# City of Malibu

## BIOLOGY REVIEW REFERRAL SHEET

**PROJECT NUMBER:** CDP 17-086  
**JOB ADDRESS:** 22729 PACIFIC COAST HWY  
**APPLICANT / CONTACT:** Norman Haynie, Blue Onyx Design and Engineerin  
**APPLICANT ADDRESS:** 22741 Pacific Coast Highway #400  
Malibu, CA 90265  
**APPLICANT PHONE #:** (310) 456-5515  
**APPLICANT FAX #:** (310) 456-9821  
**APPLICANT EMAIL:** norm@blueonyxdesign.com  
**PLANNER:** Lilly Rudolph  
**PROJECT DESCRIPTION:** New 39-Room Boutique Hotel - Sea View Hotel

## GEOTECHNICAL REVIEW SHEET

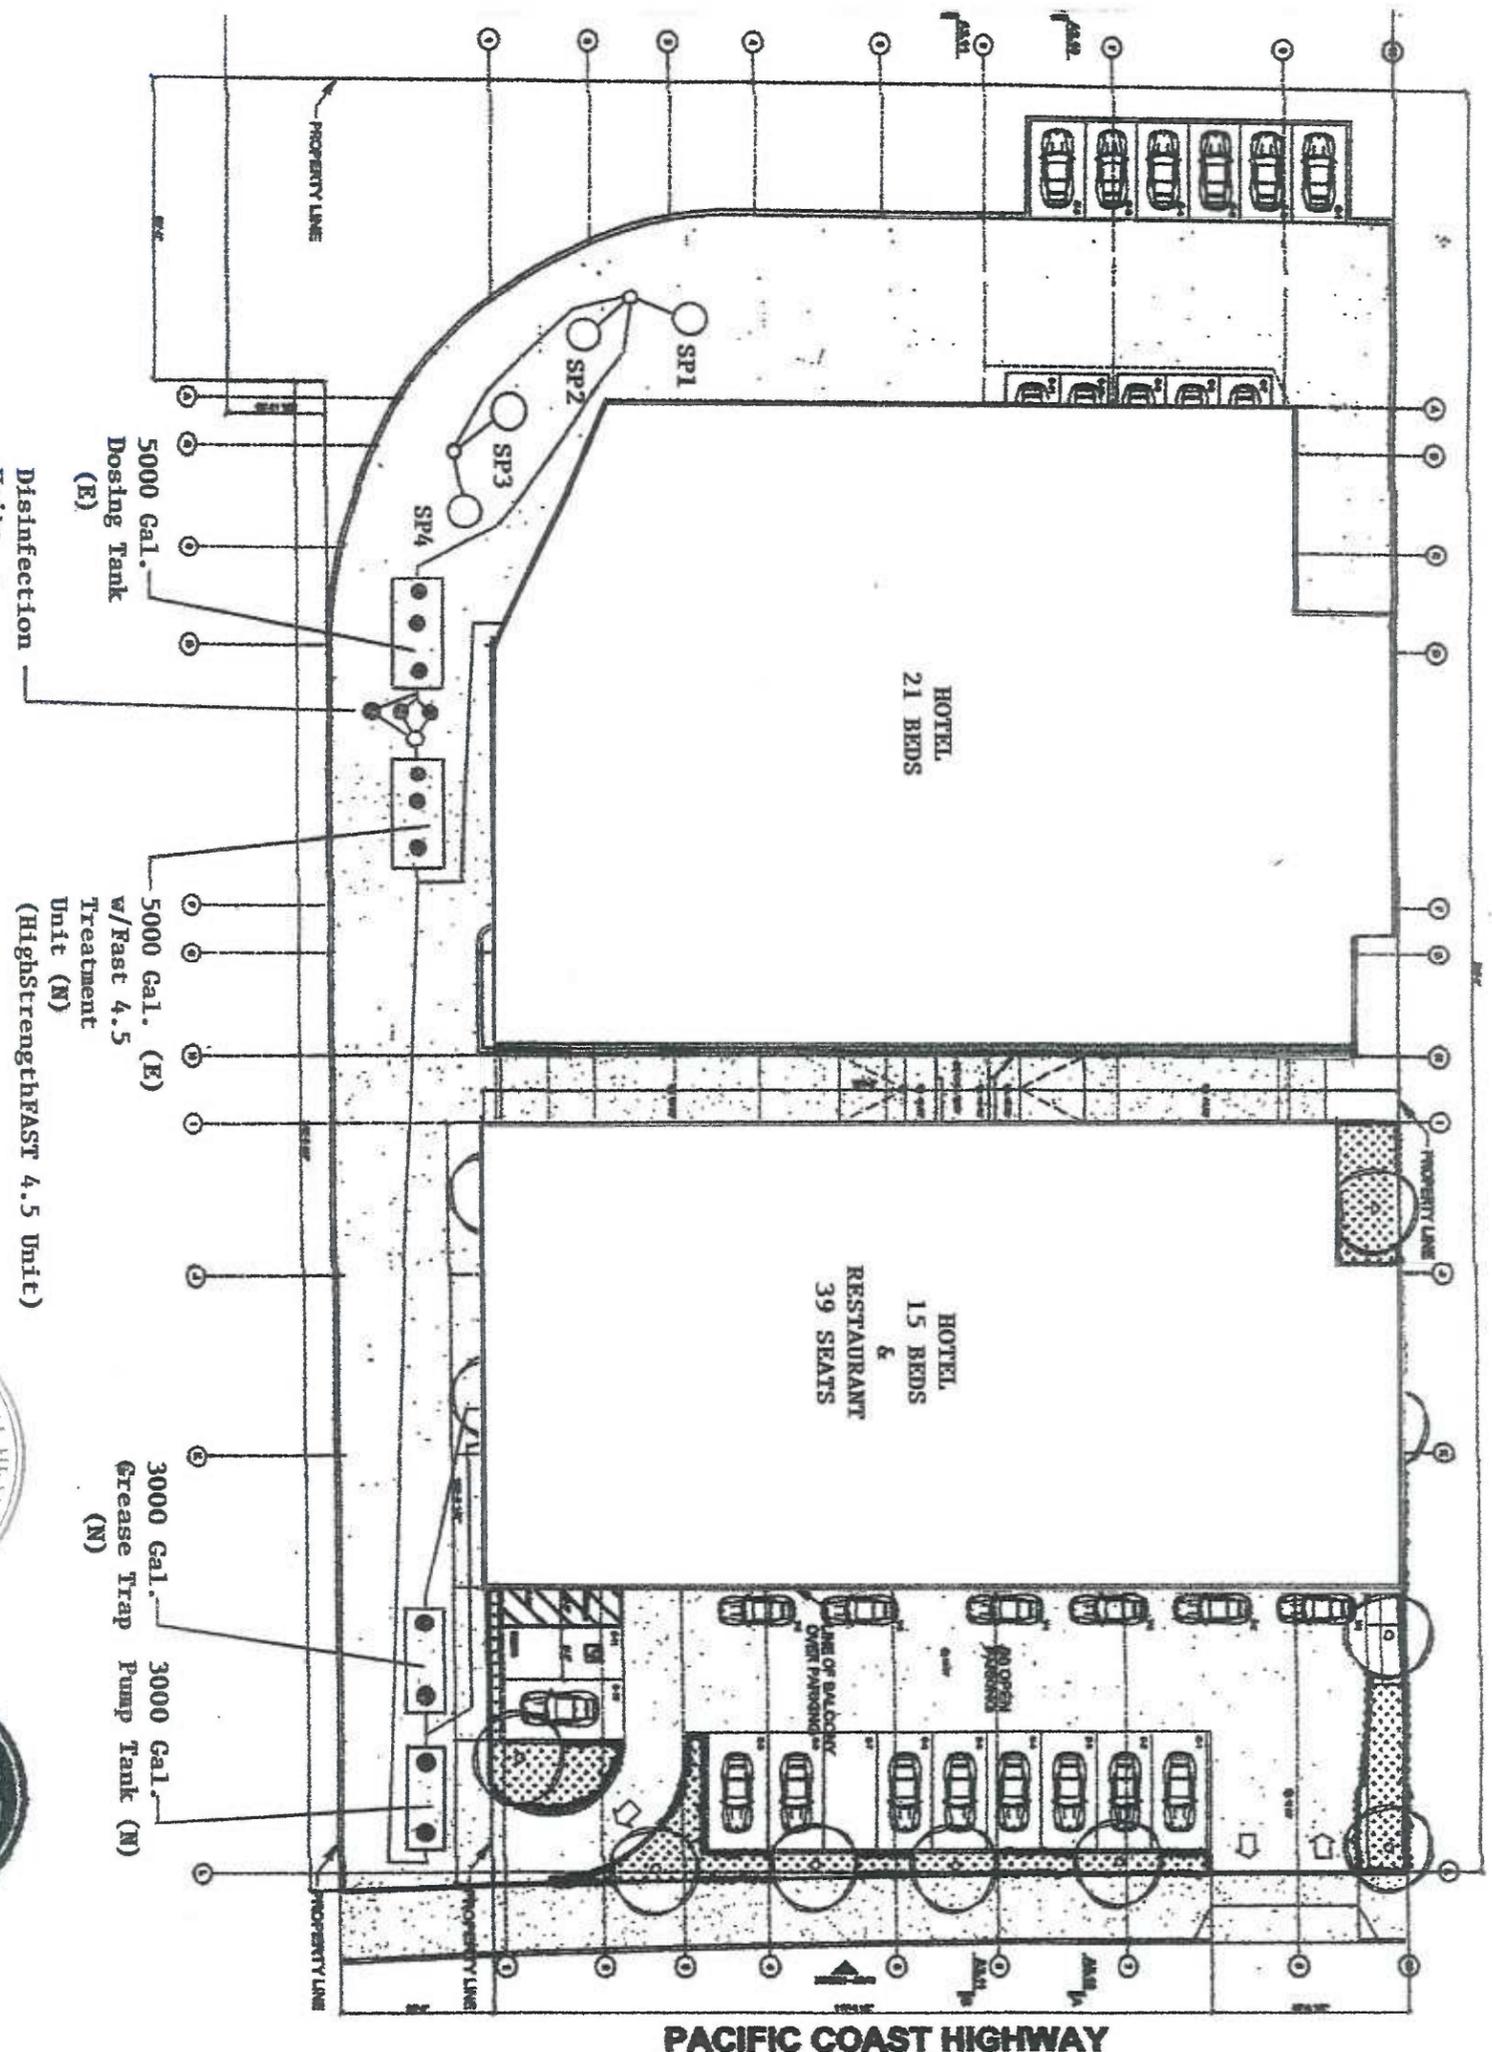
1. This conformance review is for a new 15 unit hotel with 39 seat restaurant, 21 unit hotel and renovated onsite wastewater treatment system (OWTS). The renovated OWTS shown conforms to the requirements of the City of Malibu Plumbing Code (MPC) and the Local Coastal Plan (LCP).
2. This conformance review relates only to the minimum requirements of the MPC, and the LCP, and does not include an evaluation of any geological or other potential problems, which may require an alternative method of wastewater treatment.
3. This conformance review is valid for one year, or until MPC, and/or LCP, and/or Administrative Policy changes render it noncomplying.

1. A conditional use permit and a covenant to hold the two properties as one (22729 Pacific Coast Hwy. and 22741 Pacific Coast Hwy) must be obtained from the Planning Department and submitted to the Environmental Health Administrator.
